COMMITTEE: Planning Committee
MEETING DATE: 13 January 2026
BY: Depute Chief Executive – Resources and Economy
REPORT TITLE: ECU Consultation Response

ECU Application No. ECU00005089

Proposal Electricity Act 1989 – Application for construction and operation of a repower of Crystal Rig 1 wind farm. Consisting of up to 10 wind turbines including six turbines with a maximum overall height (to blade tip) of up to 230 m and the remaining four turbines with a maximum overall height (to blade tip) of up to 200 m

ENERGY CONSENTS UNIT (“ECU”) CONSULTATION: PROPOSED CRYSTAL RIG 1 WIND FARM REPOWER ON LAND LOCATED APPROXIMATELY 10KM SOUTH OF DUNBAR AND APPROXIMATELY 40KM EAST OF EDINBURGH, WITHIN THE LAMMERMUIR HILLS (REFERRED THROUGHOUT THIS REPORT AS “CRYSTAL RIG 1 REPOWER”), EAST LOTHIAN COUNCIL’S RESPONSE

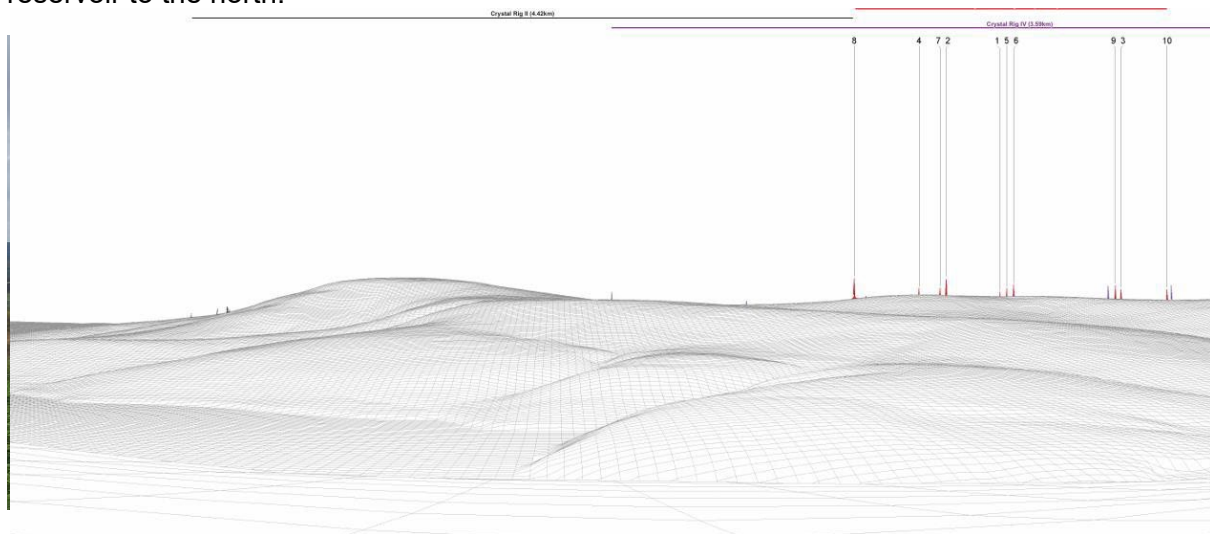
We had concerns that the ZTV showed visibility of turbines within this SLA and the impact this may have on the setting of the Whiteadder Reservoir and Spartleton. The applicants submitted a wireline from the core path to the east of Priestlaw Hill.

The photograph below shows the direction of this view with Spartleton rising beyond the reservoir to the north.

The wireline clearly shows that the turbines, although visible in this view, do not intrude behind Spartleton and therefore do not impact on the setting of the reservoir. The wireline does however indicate the increased visibility of proposed turbines compared to the existing turbines in this view.

VP21 Barns Ness

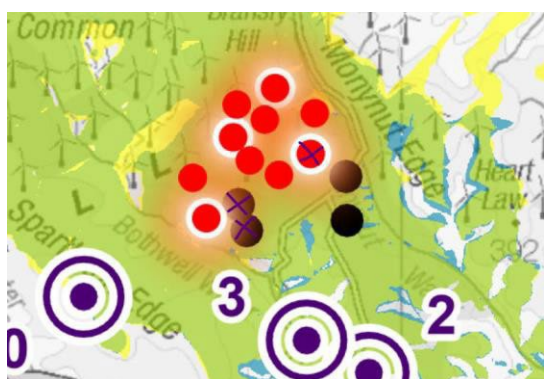
The proposed turbines sit beyond the turbines of Aikengall I and II in this view. This reduces their prominence in the daytime. Two hubs with visible aviation lighting (1 and 10) are visible from here and this will introduce lighting within the hills where there is none at the moment. This has the effect of introducing development in the hills into the night time view from the coast (and the Dunbar to Barns Ness Coast SLA). This viewpoint has not been included in the detailed assessment in the LVIA.
